## STS-107 FLIGHT READINESS REVIEW

# BACKUP INFORMATION

## PREVIOUS FLIGHT ANOMALIES BACKUP

# STS-109 PREVIOUS FLIGHT ANOMALIES BACKUP

## ORBITER ACTIVE THERMAL CONTROL SYSTEM (ATCS)

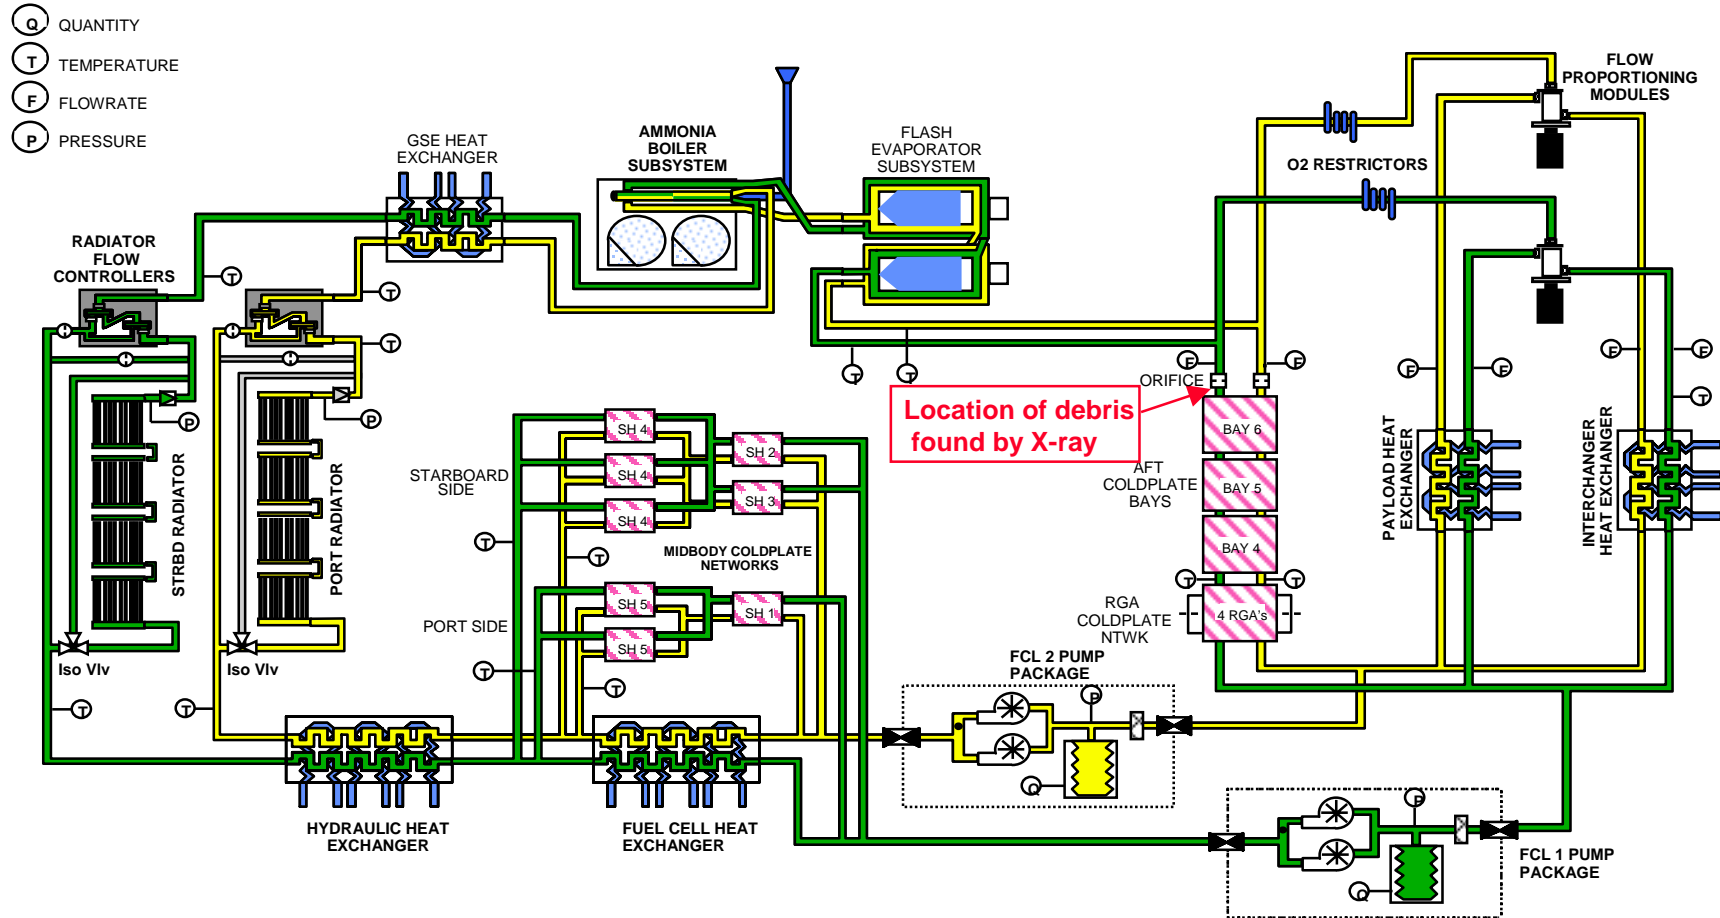
- Freon coolant loop (FCL) 1 aft cold plate (ACP) flow dropped from 305 to 225 lbs/hr after MECO

- Approximately ten minutes after lift-off, the FCL 1 ACP flow rate dropped from 305 lbs/hr to 225 lbs/hr, then to 195 lbs/hr when the FCL was reconfigured to rad flow
  - Data review confirmed that the flow reduction was caused by a restriction in the ACP leg
- The flow rate stabilized, and analysis determined that adequate flow would still be available to provide sufficient cooling for the remainder of STS-109

- During post-flight troubleshooting, a piece of debris was found stuck in the upstream side of the orifice between the FES and the aft coldplate network
- FCL 1 was de-serviced and de-brazed to allow extraction of the contaminant
  - Laboratory analysis confirmed that segment of braze preform became detached during brazing
- More x-rays were taken at other suspected locations after power-down to ensure no additional FOD is present in either loop 1 or 2 (see next slides)
  - Included x-rays of three potential traps in the RFCAs
- Visual inspections of FCL 1 FPM & pump inlet filters were also performed
  - FPM 1 and pump inlet filters replaced

## X-rayed Locations for FES, Radiator and RFCA

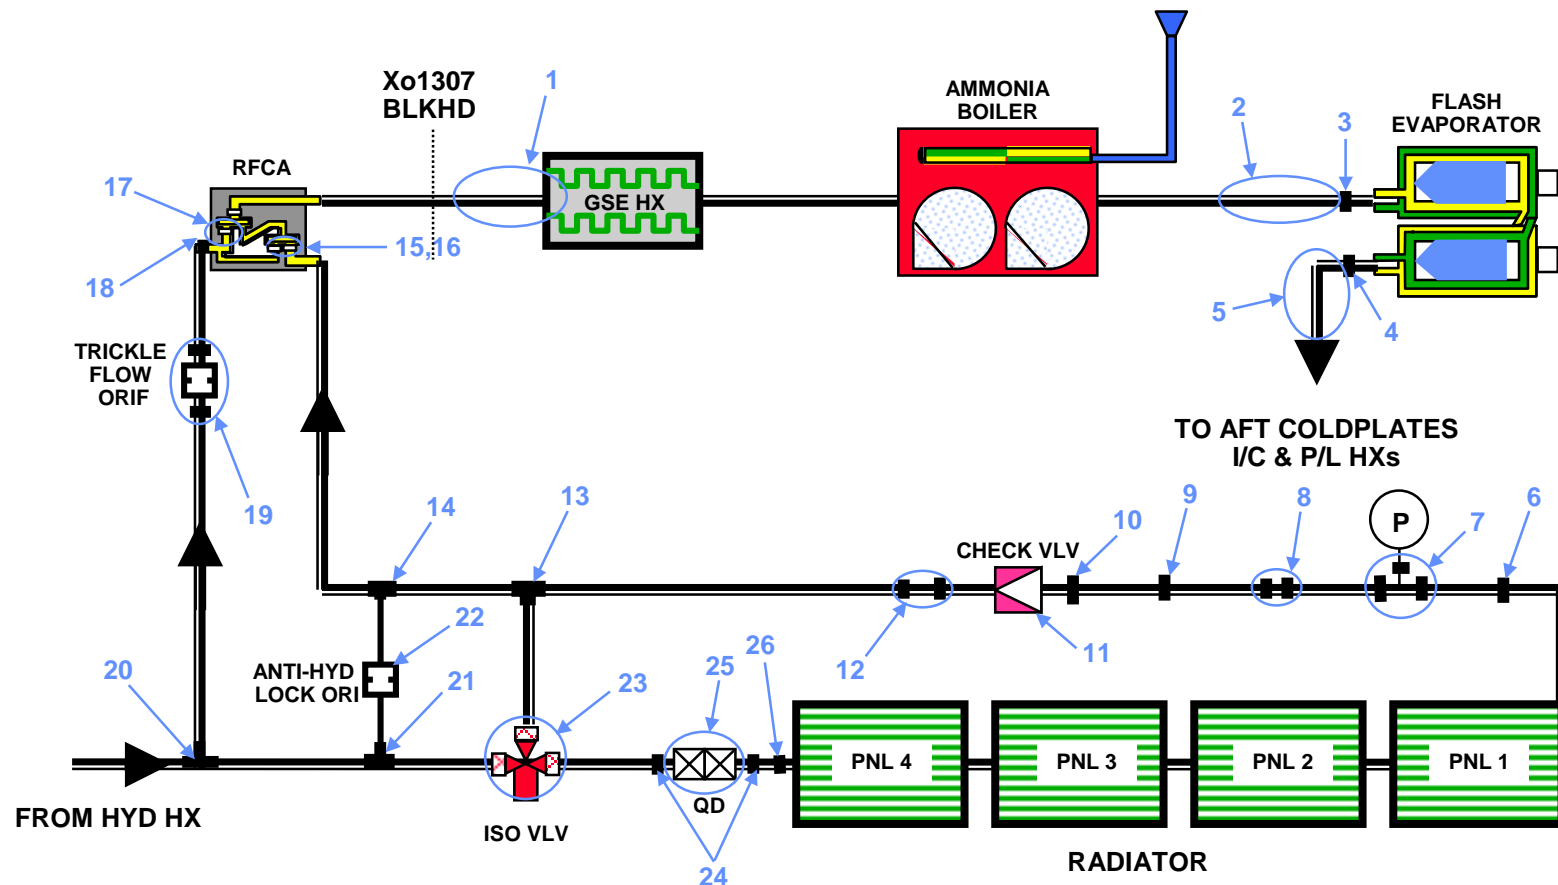
- 1 – 3/4" – 3/8" reducer tee
- 2 – Coldplate flow sensor inlet braze/180 deg inlet tube bend
- 3 – Coldplate flow sensor outlet braze/90 deg outlet bend to X<sub>O</sub>1365 bulkhead
- 4 – Coldplate flow orifice (debris lodged here)
- 5 – Avionics bay 6 inlet tube (90 deg bend) [FCL 1 only]
- 6 – FPM (Flow Proportioning Module) inlet/outlet brazes
- 7 – FPM inlet/outlet filters (3 each)
- 8 – FPM outlet tube bend including entire line to P/L flow sensor inlet
- 9 – Payload flow sensor including inlet/outlet brazes
- 10 – Entire line from payload flow sensor to inlet of P/L HX
- 11 – P/L HX inlet header and braze

- 1 – GSE HX inlet header/tube run upstream to 1<sup>st</sup> clamp
- 2 – FES inlet line from 1<sup>st</sup> line clamp upstream to inlet braze
- 3 – FES inlet braze
- 4 – FES outlet braze
- 5 – FES outlet line down to 1<sup>st</sup> clamp (including male/female mechanical fittings)
- 6 – Tube/tube braze
- 7 – Tee (3 brazes)
- 8 – Elbow to tube/flexline (2 brazes)
- 9 – Flexline braze to tube flange support
- 10 – Tube flange support outlet braze to dynatube braze TP231B

- 11 – Isolation check valve
- 12 – Elbow brazes to check valve/tube\*
- 13 – Tee (3 brazes)\*
- 14 – Tee (2 brazes), brazed to item 13 tee\*
- 15 – RFCA flow control valve inlet filter (cold)
- 16 – RFCA flow control valve inlet filter (hot)
- 17 – RFCA bypass valve inlet filter
- 18 – RFCA bypass leg inlet braze\*
- 19 – Bypass orifice including inlet/outlet brazes
- 20 – Tee (3 brazes)\*
- 21 – Tee (2 brazes), brazed to item 20 tee
- 22 – Anti-hydraulic lock up orifice\*
- 23 – Iso valve body and inlet/outlet brazes (3)
- 24 – QD inlet braze at flexline interface/QD outlet braze\*
- 25 – QD interface male/female
- 26 – Tube to tube braze\*

## Orbiter/ET 4" Disconnect

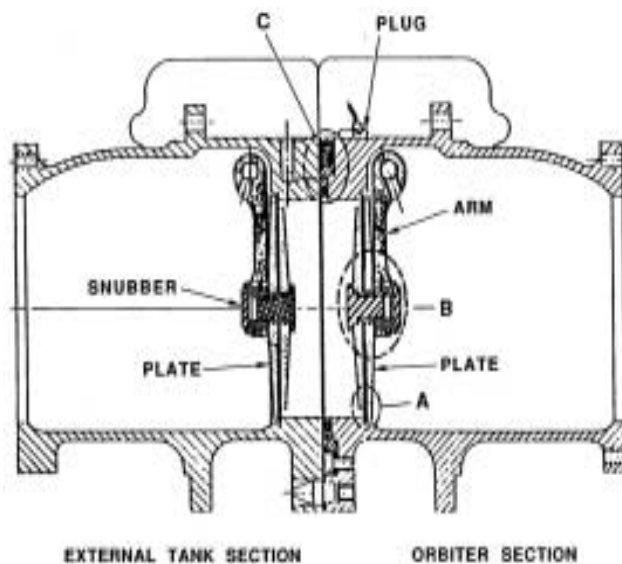
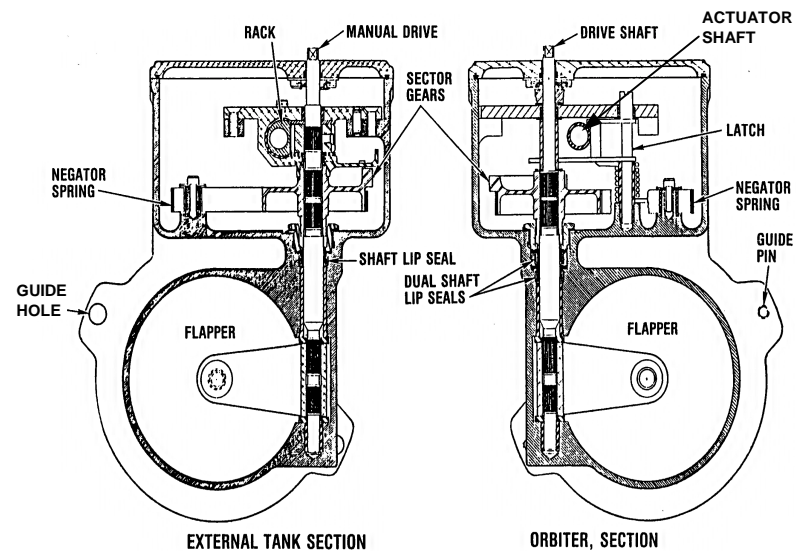
- MPS LH2 4" disconnect failed to close pneumatically when commanded at MECO
  - Closed via back-up mechanical mode at ET/Orbiter umbilical separation

- Failure of the 4" disconnect to close pneumatically in the case of a pre-MECO SSME shutdown or pad-abort results in inability to isolate the affected SSME from the hydrogen in the ET
  - No concern for nominal mission
    - Minor helium loss during entry if disconnect fails to close in back-up mechanical mode

- Disconnect failure to close pneumatically is only critical for uncontained SSME shutdown
  - Probability of SSME catastrophic shutdown is remote
- Borescoped new disconnect and verified no damage
- OMRS verification of disconnect function accomplished prior to propellant loading
- No history of disconnect failure to close via mechanical back-up separation mode
  - Prevents helium loss during entry

## SUPPLY WATER SYSTEM

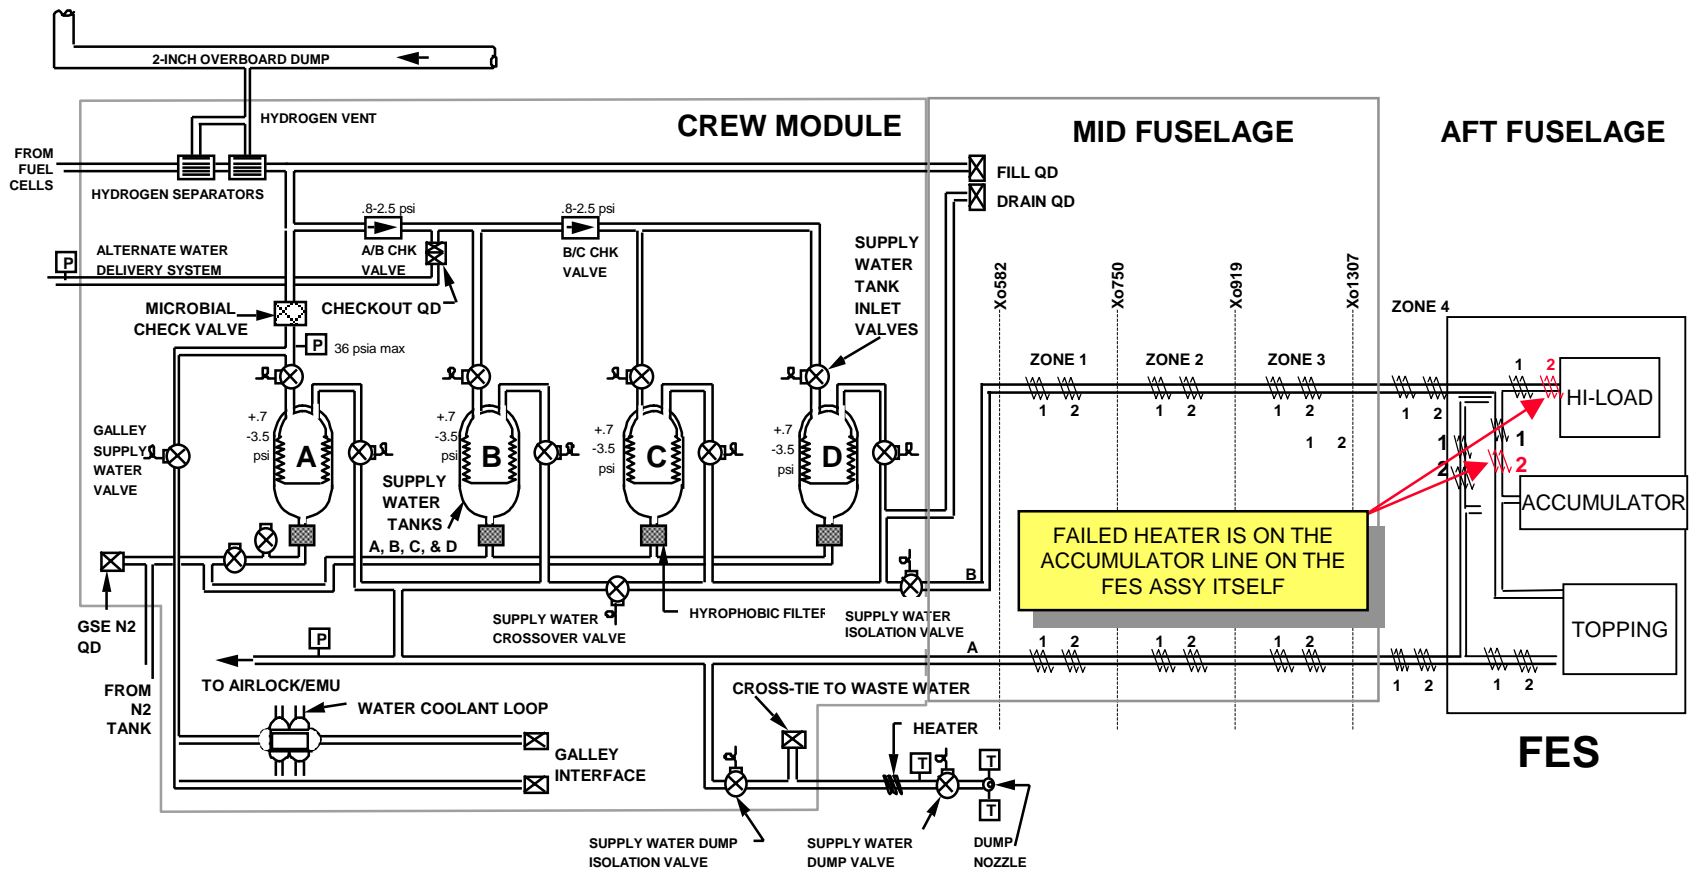
- FES accumulator/hi-load H<sub>2</sub>O feedline B (starboard) heater system 2 zone 4 failed off

- Accumulator line temperature (V63T1894A) and hi-load feed line temperature (V63T1896A) dropped to 50 °F & 60 °F respectively at MET 008:15:15 indicating a heater failure
- The crew switched to heater string 1 and the system performed nominally for the remainder of the mission

- Post-flight troubleshooting isolated the problem to a bad thermal switch
  - Switch (S0V63S51) was replaced and successfully retested
  - In addition, the feedline B accumulator line temp sensor (V63T1894A) was not responding during troubleshooting
    - Sensor was also replaced and successfully retested

- Problem was isolated to a bad thermal switch which has been replaced
  - Post-repair verification - good results
- There are two redundant heater strings per feedline, providing temperature control to prevent freezing
- With loss of both heater strings, a contingency procedure is in place to purge the affected line to prevent freezing (safing) and allow recovery of the system for entry
  - Redundant feedline (A) maintains FES capability

### **FRCS Dynatube B-nut Retainers Installed by MR:**

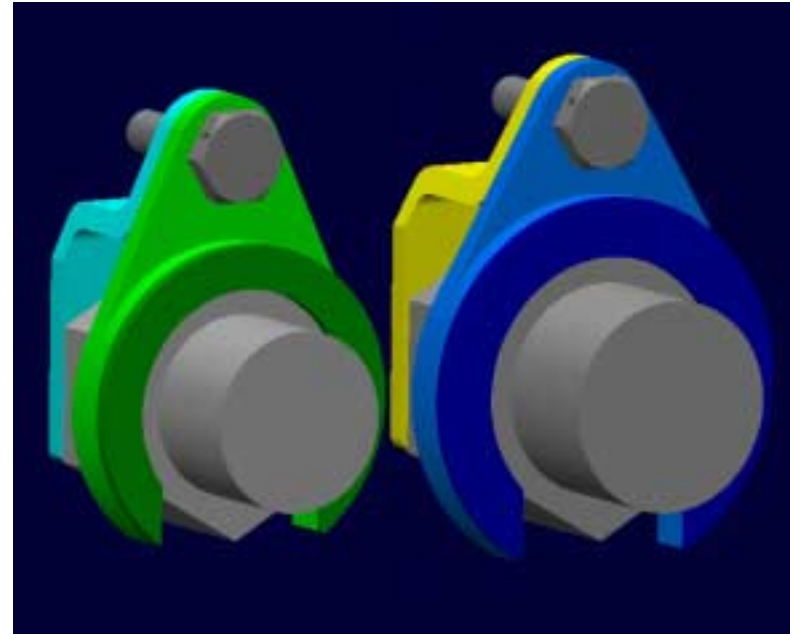
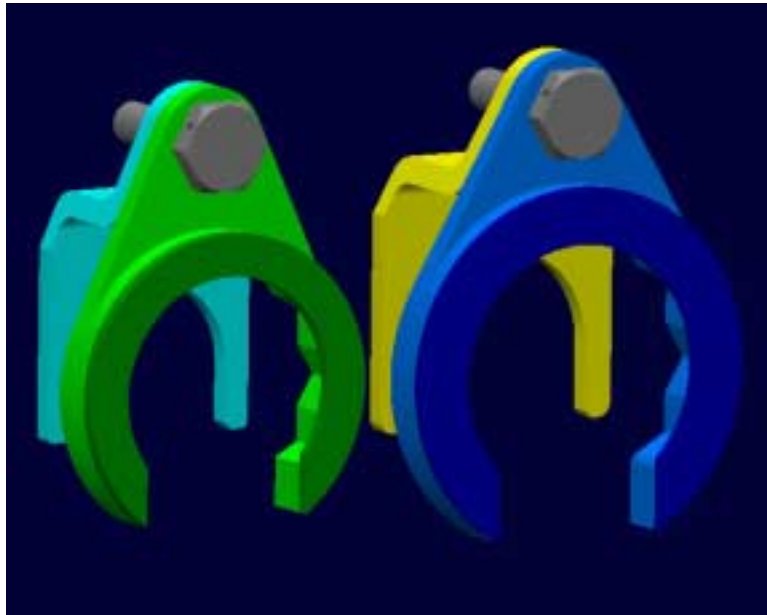
- Low “break-away” torques noted on LP01 (OV-103) thruster Dynatube fittings lead to pre-load relaxation concern
  - Seal saver from L1A found damaged due to incorrect installation
- OMS/RCS PRT recommended removal of FRC2 to install retainers, ultimately to protect against joint separation due to an improperly installed seal saver
  - FRC2 is only pod/module without safety wire on thruster Dynatube fittings
- Retainers were designed to capture Dynatube fittings with provision for installation of safety cable
- Stress/Dynamics assessment verified acceptability for flight
- FRC2 to be modified to OV-103 & subs safety-wire configuration at next OMDP

## OME Pitch Clevis Mount (Actuator Not Installed)

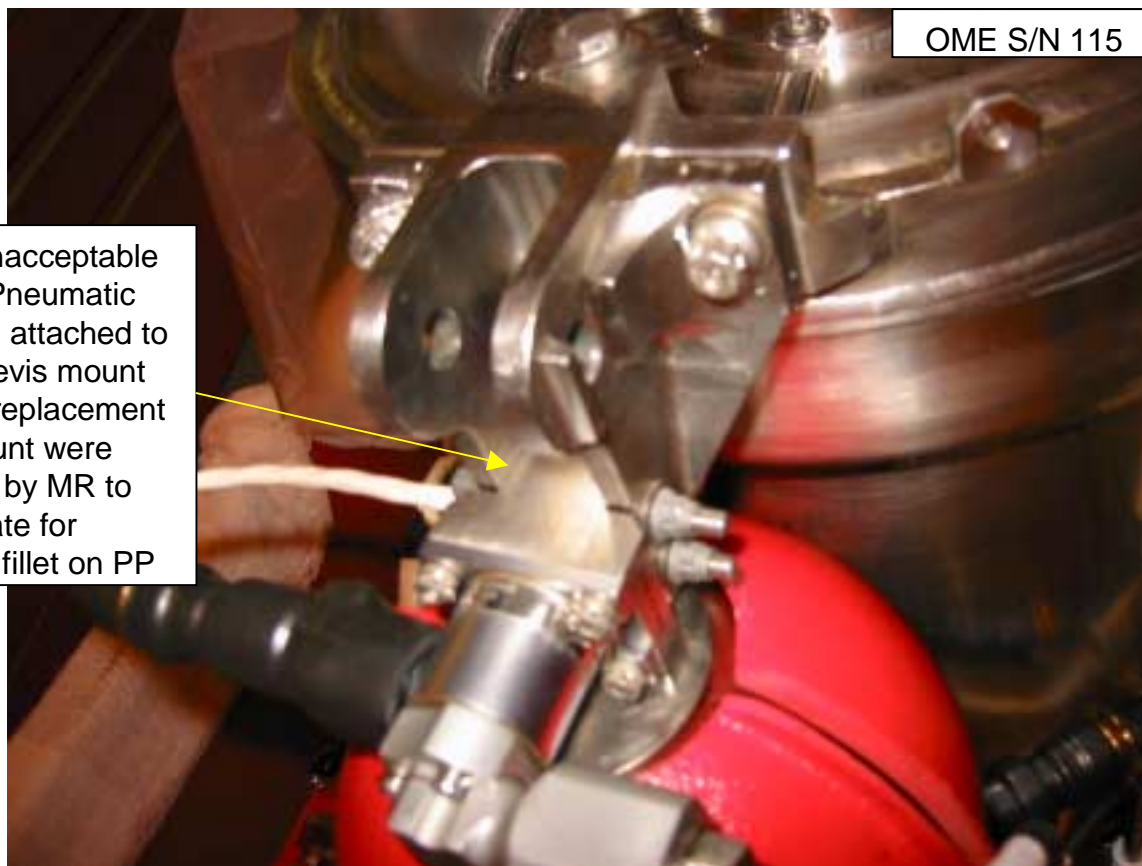
- Original clevis mount on Orbital Maneuvering Engine (OME) S/N 116 not manufactured per print
  - The area where the pneumatic pack bracket attaches via two thru-bolts was inadvertently machined ~.021" oversize
  - PRT recommended replacement due to concerns with excessive play in the pneumatic pack bracket attachment and thinning of the clevis where it was machined
  - Replacement part was obtained from WSTF
- With new clevis mount installed, the pneumatic pack could not be attached due to misalignment of the bolt holes
  - Pneumatic pack attach structure also not per print - fillet radius too large, causing clevis mount tangs to contact fillet before bolt holes are in alignment

- Area of unacceptable gap with Pneumatic Pack (PP) attached to original clevis mount
- Tangs of replacement clevis mount were machined by MR to compensate for oversized fillet on PP

- Plan was developed to machine clevis tangs to compensate for oversized fillet (chamfer 0.08" off edges)
- Boeing/JSC Stress verified integrity of the clevis mount is not adversely affected
  - Chamfer does not protrude into bolt holes
- Measurements of both the removed part and the replacement part verified acceptable difference in pitch actuator mounting hole location without adjustment of actuator
- Travel and Response and Heat Shield Clearance checks were performed during OMS/RCS Flight Control Checkout (OMI V1238) with no anomalies

## Modified (Chamfered) OMS Engine Pitch Clevis

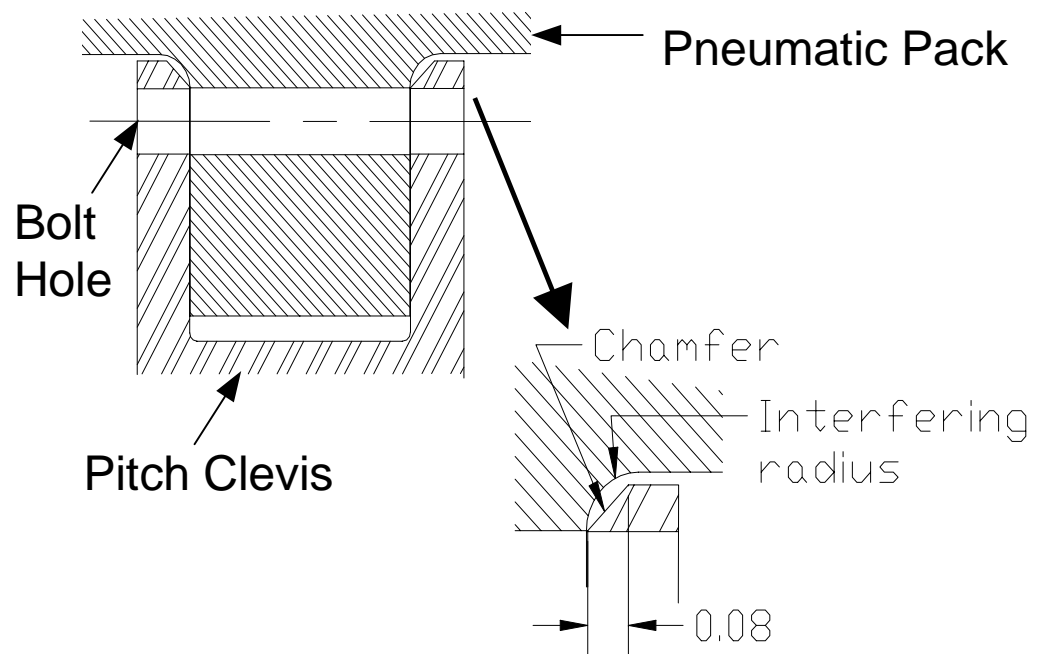
Top view of pitch clevis modification  
OMS engine S/N 116
